**Statement of Response to ABP's Pre-Application  
Opinion under ABP Ref.: 307260-20**

**Proposed Strategic Housing Development**

**Fosterstown North, Dublin Road / R132,  
Swords, Co. Dublin**

**April 2022**

**Figure 5: Extract from the Architectural Design Statement illustrating the consideration of the Fosterstown Masterplan and Scheme Evolution**

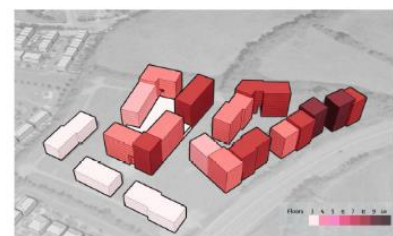
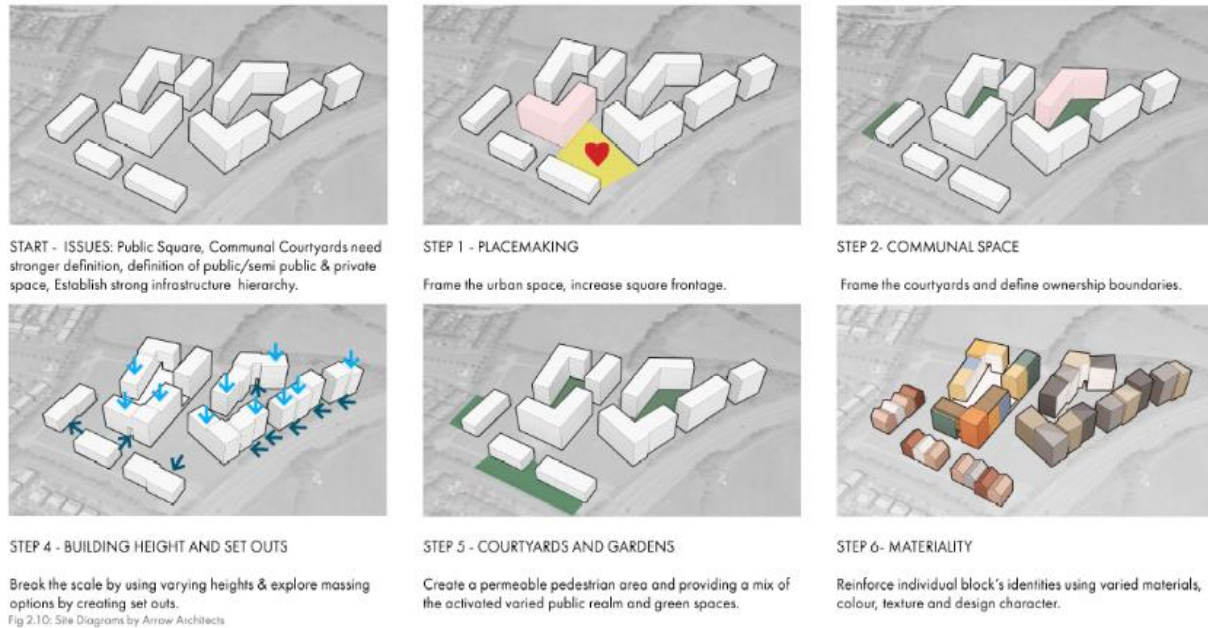
***“2. Further consideration of the documents as they relate to the design and heights of the proposed buildings. In addition to the local statutory plans, the submitted documentation should have regard to the Guidelines for Planning Authorities on Building Heights and Urban Development, 2018 including its specific planning policy requirements, and the need to provide a sufficient density of development on the site and a high standard of architectural and urban design and residential amenity particularly with respect to adequate amenity areas and sunlight/daylight access. If it is proposed to materially contravene the provisions of the local area plan, then a statement justifying the contravention is required to be submitted.”***

2.6.1 Based on the initial massing studies and analysis of the masterplan further opportunities to improve the scheme have been investigated. Building heights have been carefully considered to respond to both the masterplan and project’s objectives.

Number of levels have been reduced throughout all buildings. The extra units could be achieved by filling some gaps and extending some buildings.

This study seeks to break the scale of the largest blocks and revise the location of the lowest/ highest buildings on site.

Following the heights principle shown as per Fingal County Council Masterplan (2019), while maintaining the current massing and layouts it is possible to achieve around 650 units.
